# OVERLOOK AT HOMESTEAD

## PRELIMINARY PLAN

DATE: 12/08/2023  
 BY: JS  
 DESCRIPTION: REVISED PER COUNTY COMMENTS

SP238

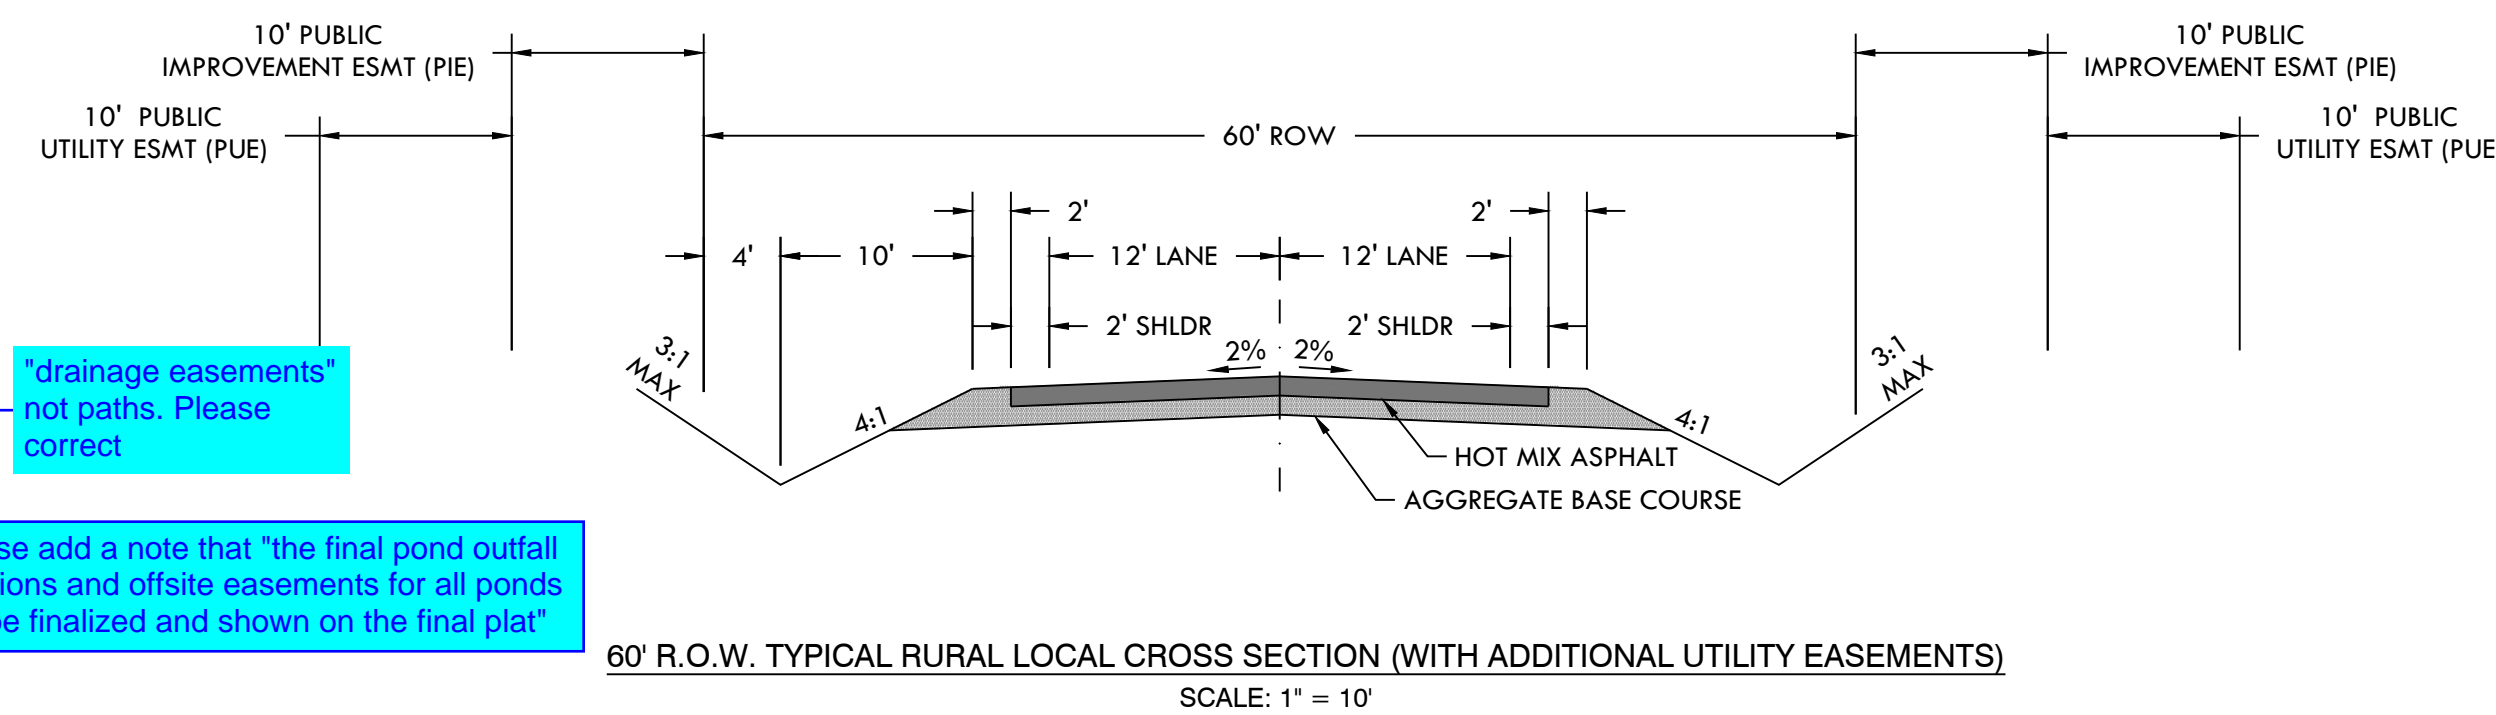
Add note: The subdivider(s) agree on behalf of him/herself and any developer of builder successors and assignees that subdivider and/or said successors and assigns shall be required to pay traffic impact fees in accordance with the El Paso County Road Impact Fee Program (Resolution No. 19-471), or any amendments thereto, at or prior to the time of building permit submittals. The fee obligation, if not paid at final plat recording, shall be documents on all sales documents and in plat notes to ensure that a title search would find the fee obligation before sale of the property.

Show or denote Tract C on drawing.

Are ponds being placed in a tract or just in a drainage easement?

"drainage easements" not paths. Please correct

Please add a note that "the final pond outfall locations and offsite easements for all ponds will be finalized and shown on the final plat"

Add note: "All property owners are responsible for maintaining proper storm water drainage in and through their property. Drainage easements as specifically noted on the plat shall be maintained by the individual lot owners unless otherwise indicated. Homeowners shall not change the grade of the lot or drainage swales within said easements, as constructed by the builder, in a manner that would cause adverse drainage impacts to properties. Structures, fences, materials or landscaping that could impede the flow of runoff shall not be placed in drainage easements."

"Detention ponds will require a maintenance access road to be contained within a easement leading to each pond."

(the access easement must be shown on the PRELIM plan and plat. Could be within the 30ft drainage easement if traversable)

### PRELIMINARY GRADING PLAN SOUTH

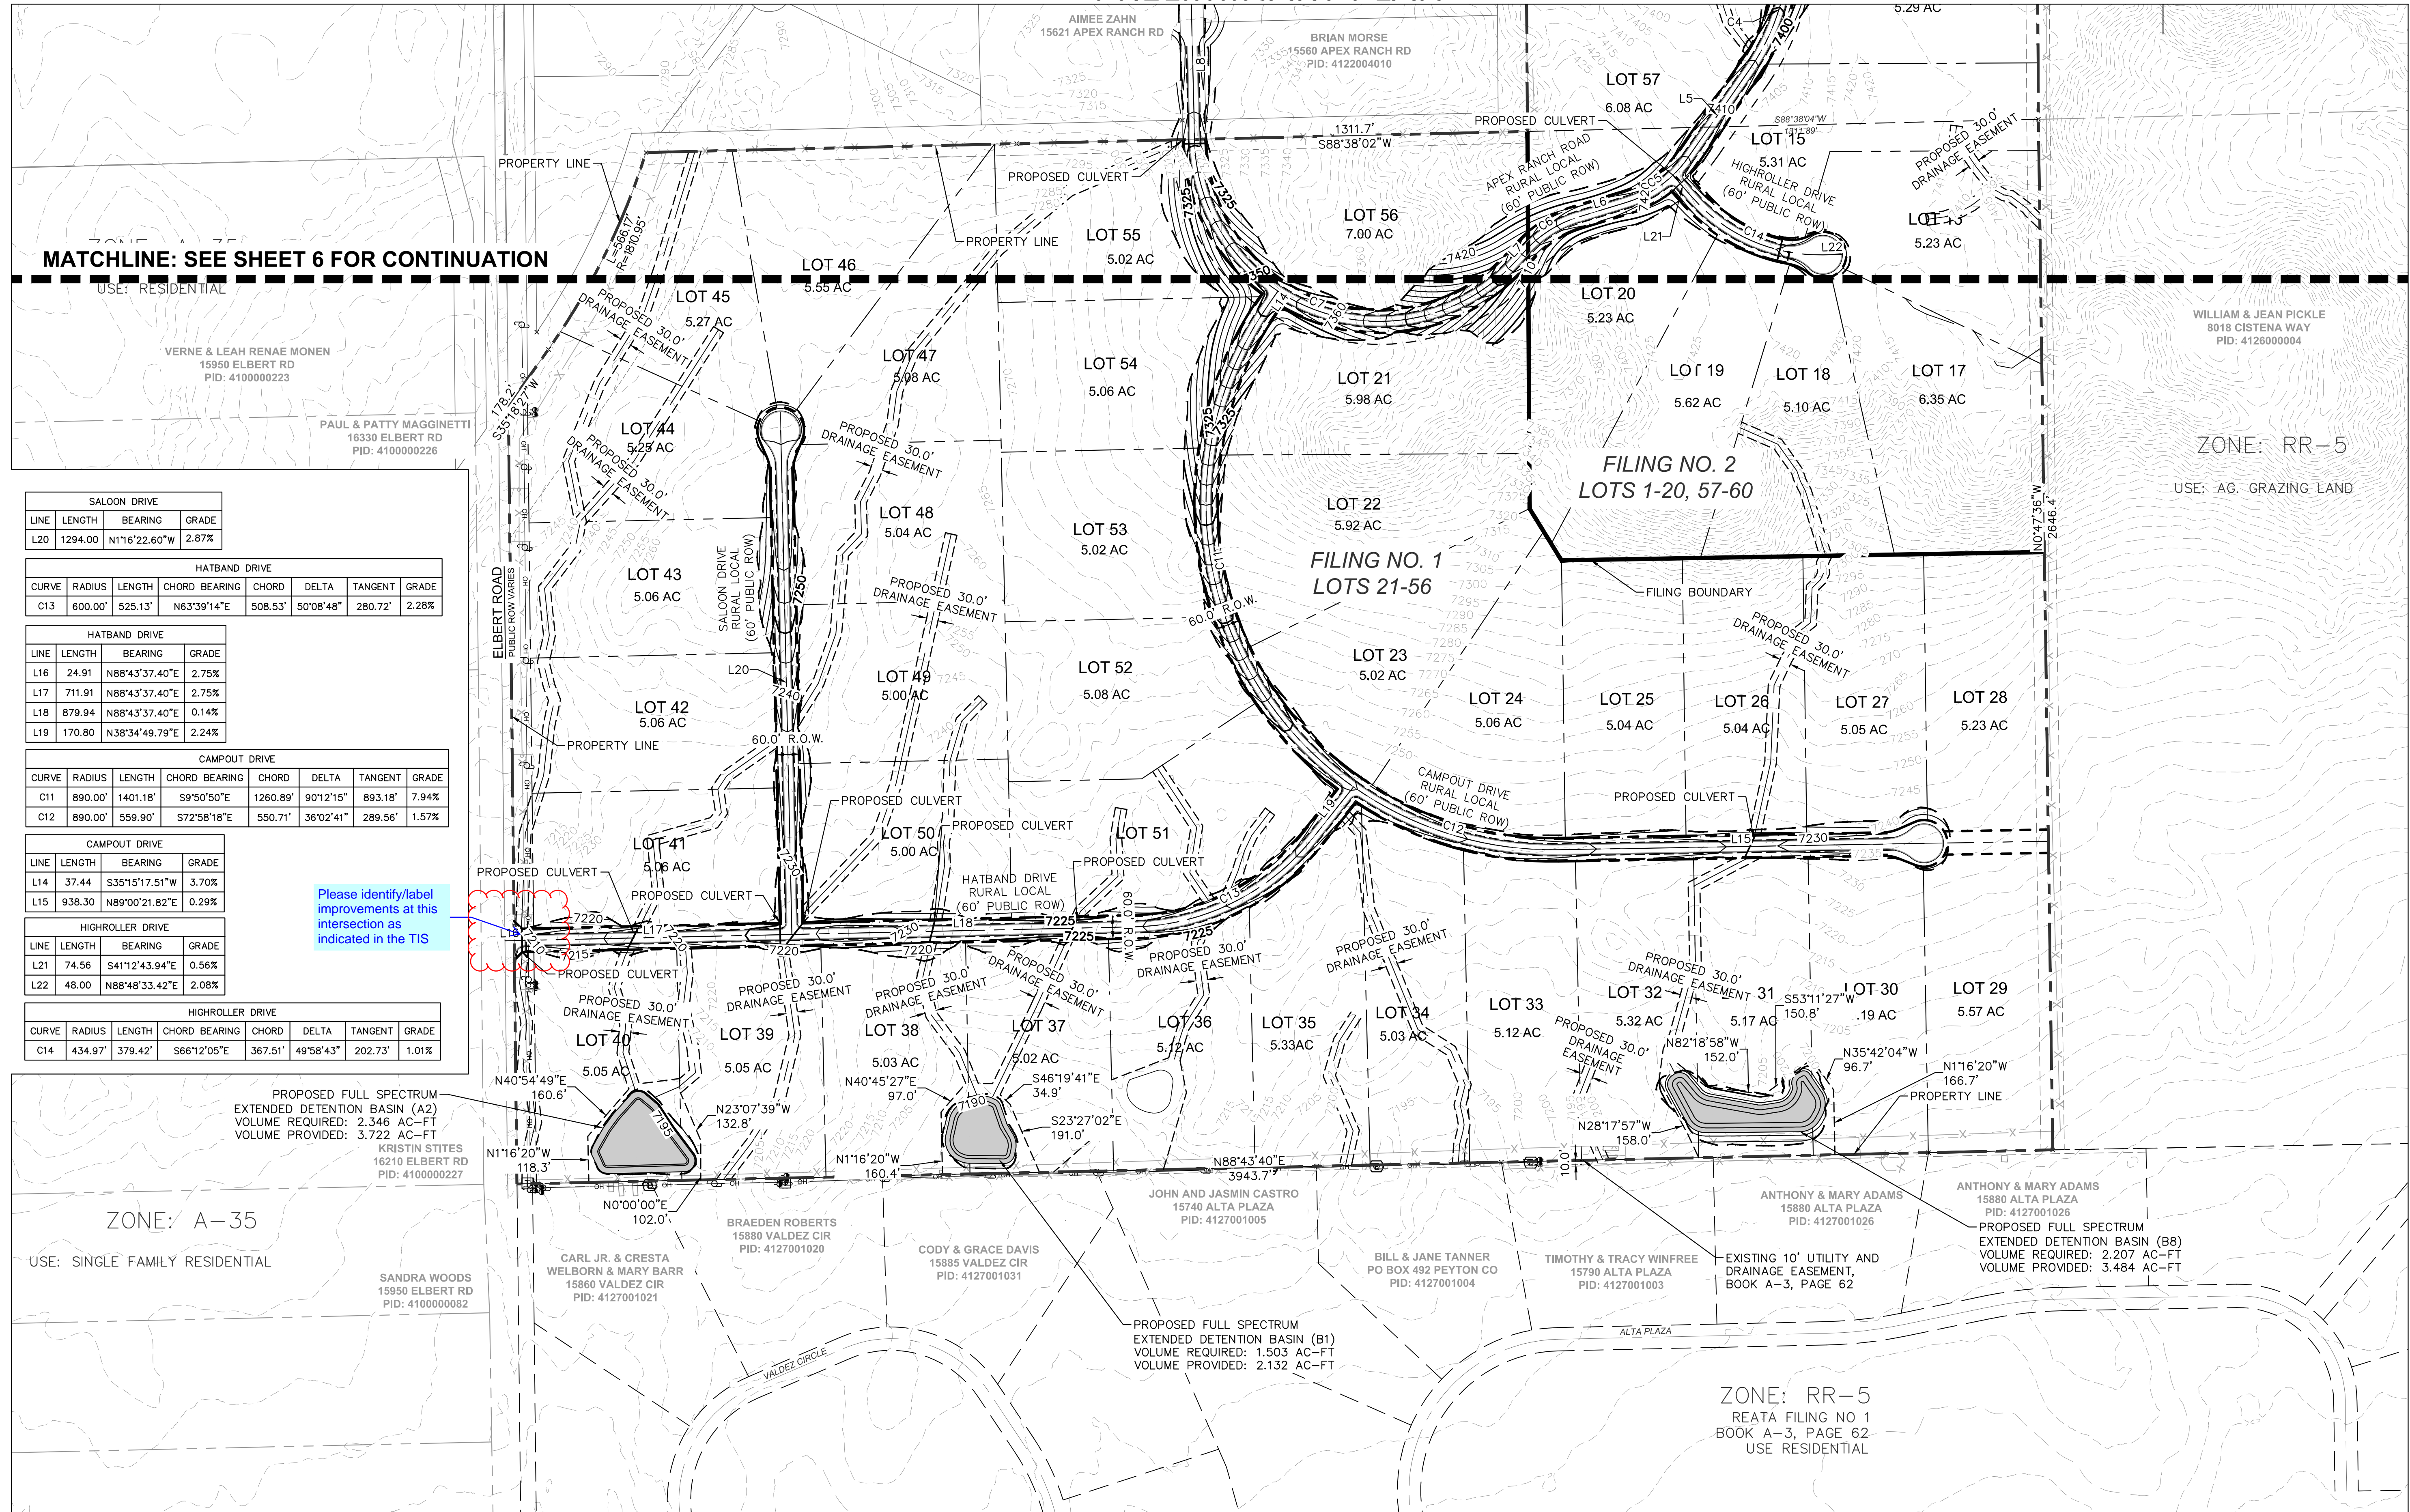
Please identify/label improvements at this intersection as indicated in the TIS
